**RE: Rio Grande Apartments
2211 Rio Grande Blvd. NW
Grading and Drainage Plans
Engineer's Stamp Date: No Date
Hydrology File: H12D024**

Based upon the information provided in your submittal received 09/07/2021, the Grading & Drainage Plans **are not** approved for Building Permit, Grading Permit and SO-19 Permit. The following comments need to be addressed for approval of the above referenced project:

MILLER ENGINEERING CONSULTANTS
Engineers • Planners
3500 COMANCHE, NE
BUILDING F
ALBUQUERQUE, NM 87107
(505) 888-7500
(505) 888-3800 (FAX)

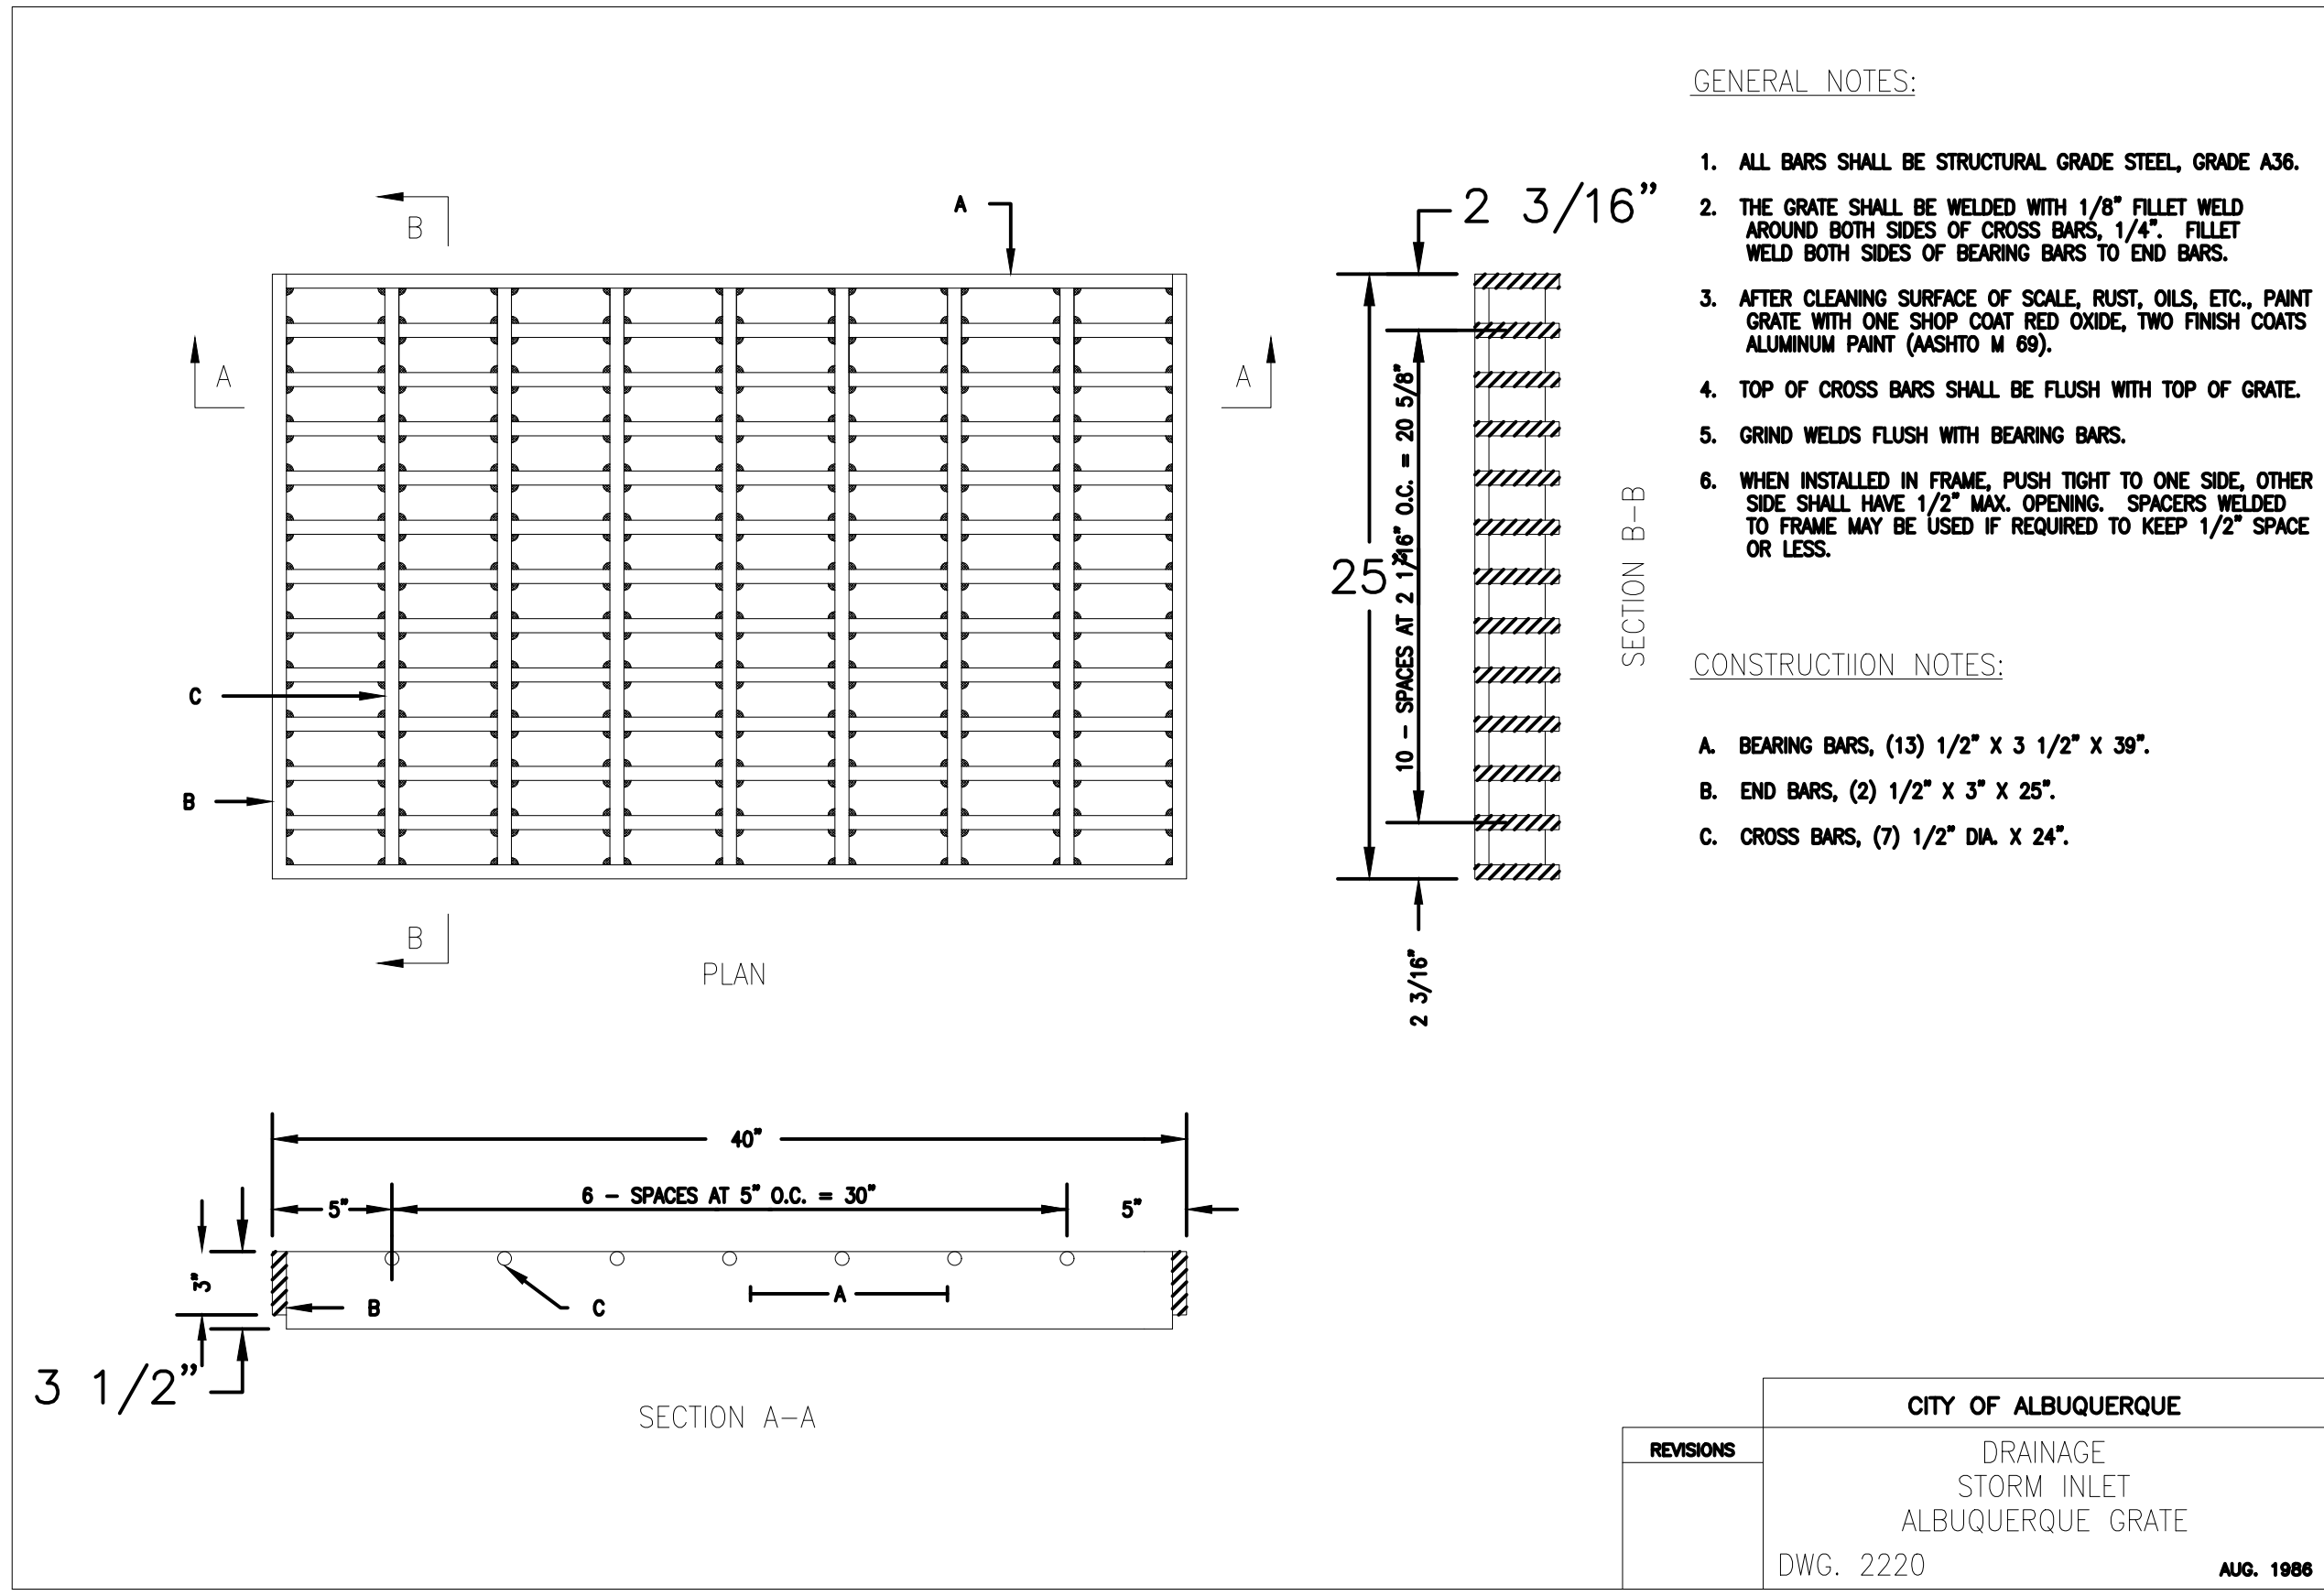
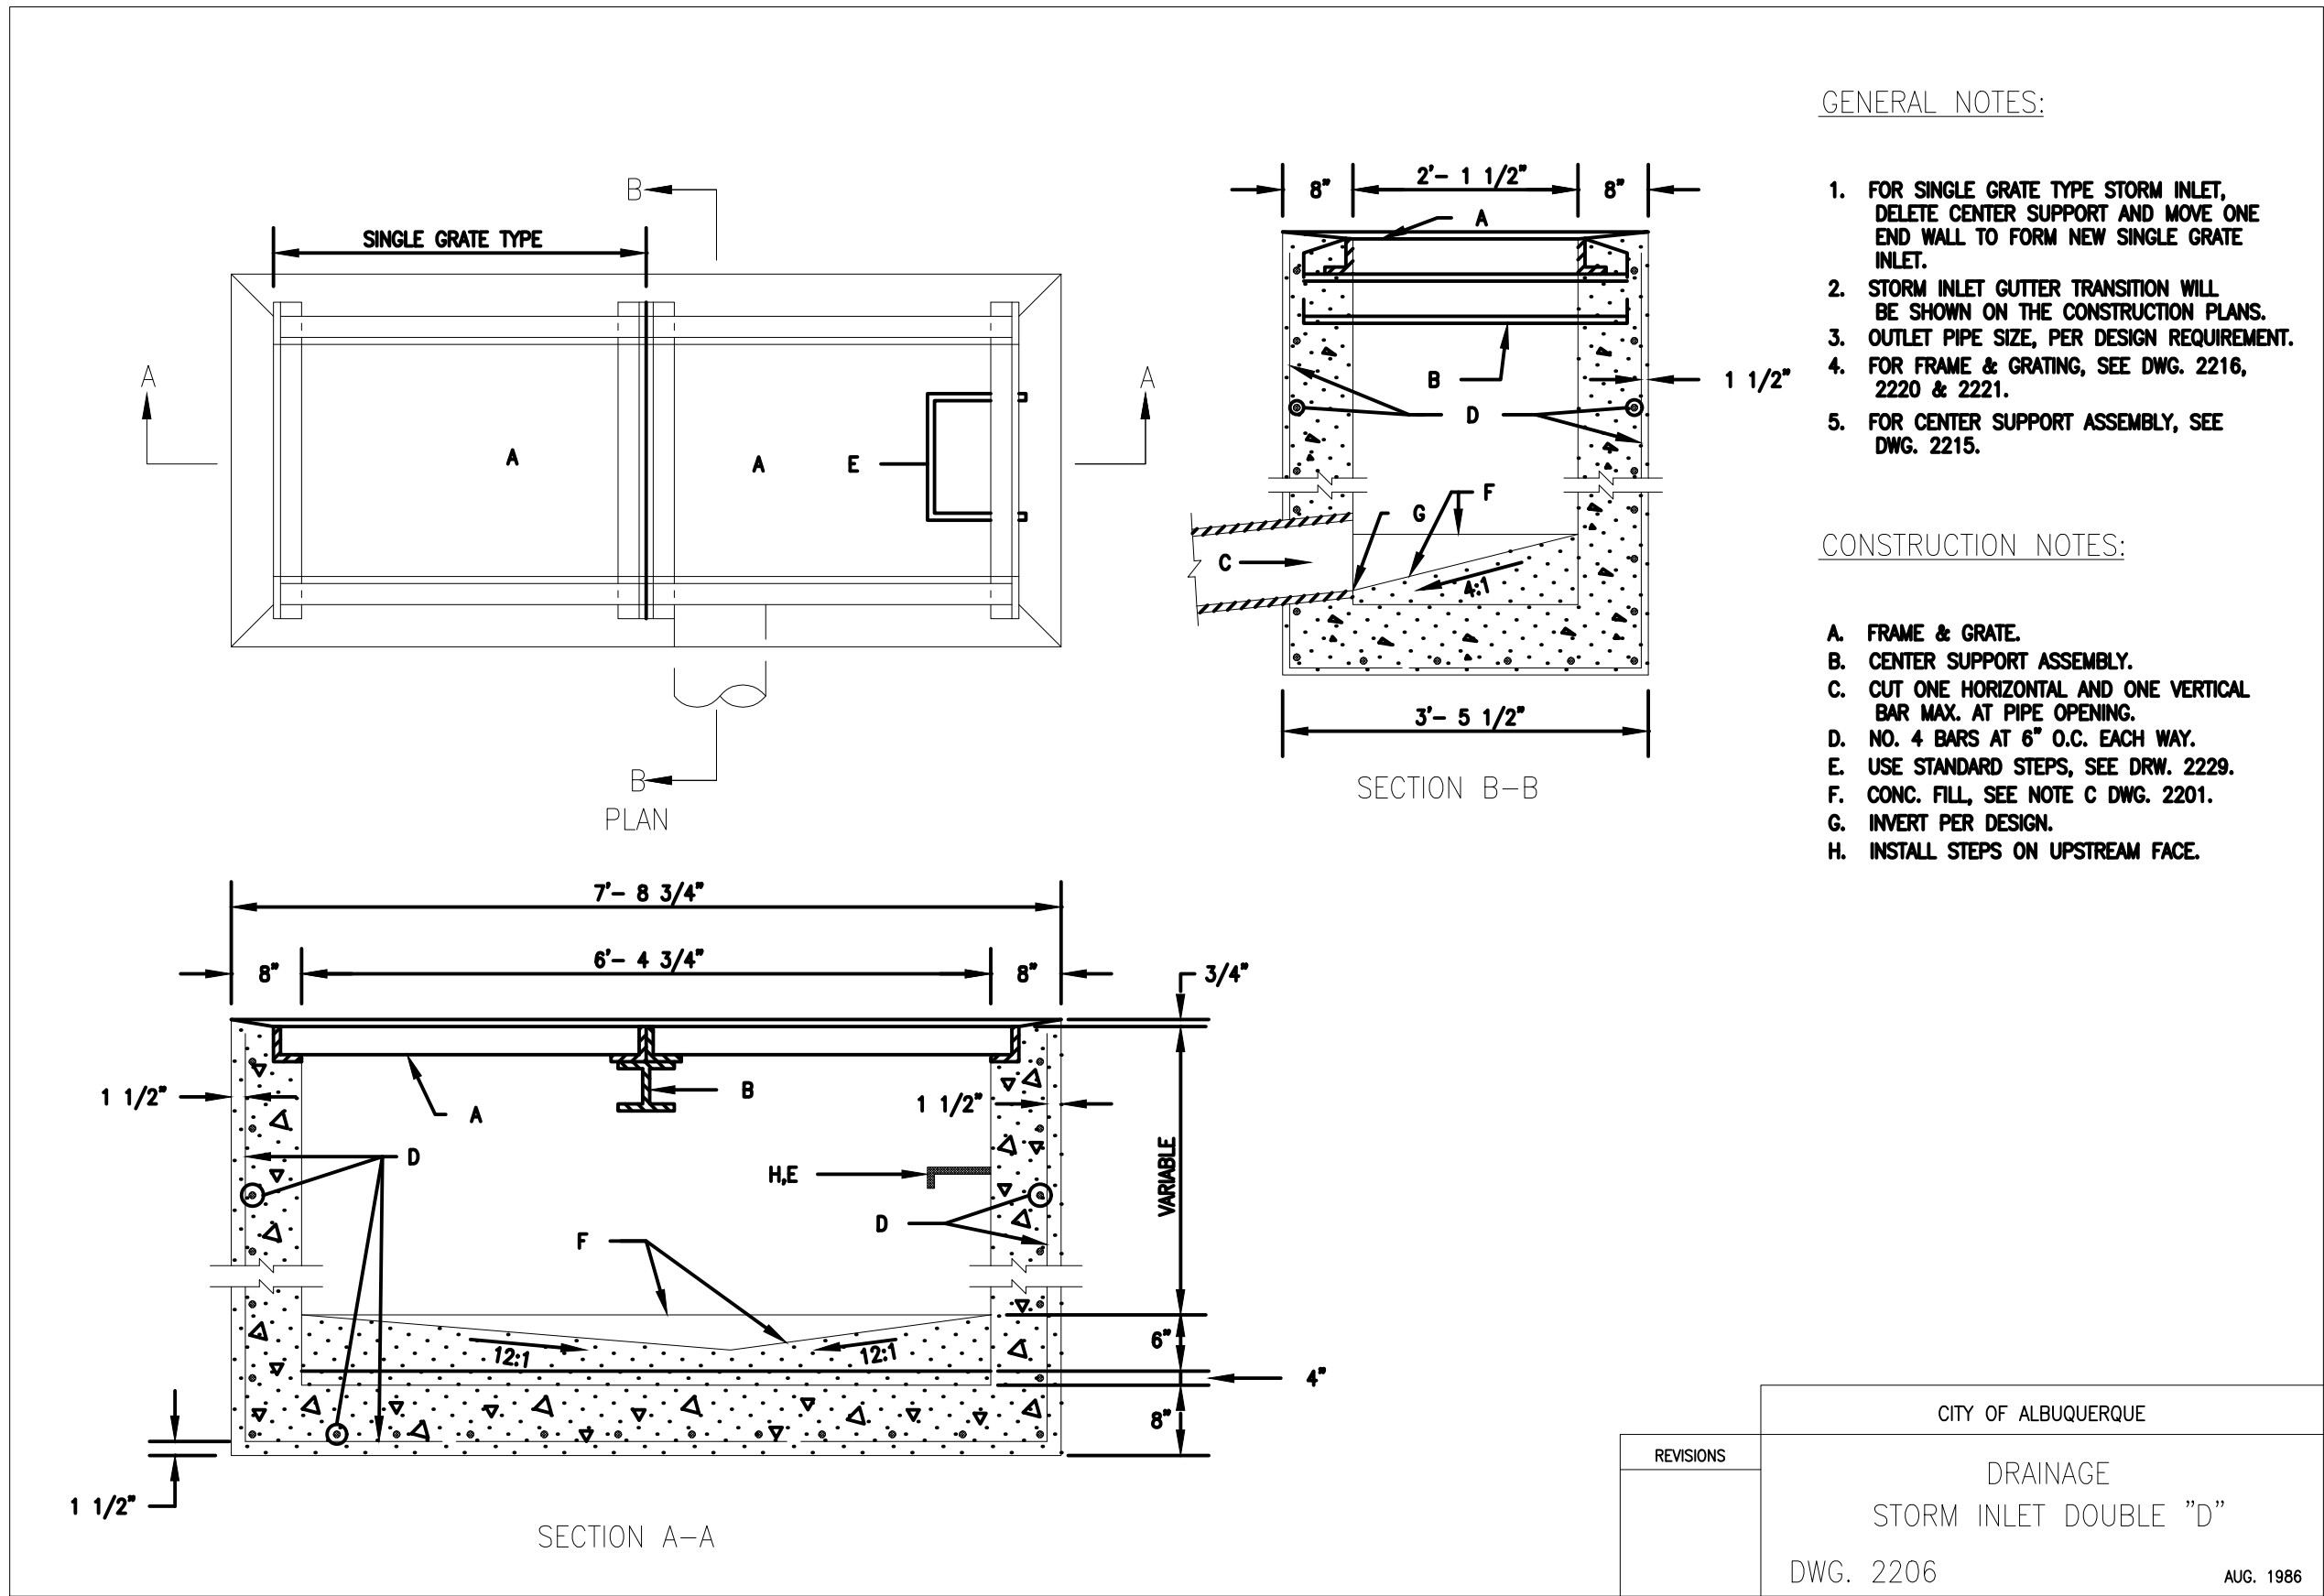
16. In the cross section, please showing property/ROW lines and add a note stating that the contractor shall waterproof the proposed retaining wall below the 100-yr 10 day water surface elevation of 4966.5 per City standards. In accordance with DPM, grading and wall construction near the property line may not endanger adjacent property or constrain its use. Please make sure that the footer for the wall stays within the project's property. Also move this onto the Grading Plan per Comment #9.

17. The remainder of the details on this sheet or either just standard City details, which don't need to be shown. Just call them out on the Grading Plan as per COA Standard Drawing xxxx.

18. Please just remove the sidewalk culvert since you are installing one in the City's R.O.W. See Comment #12.
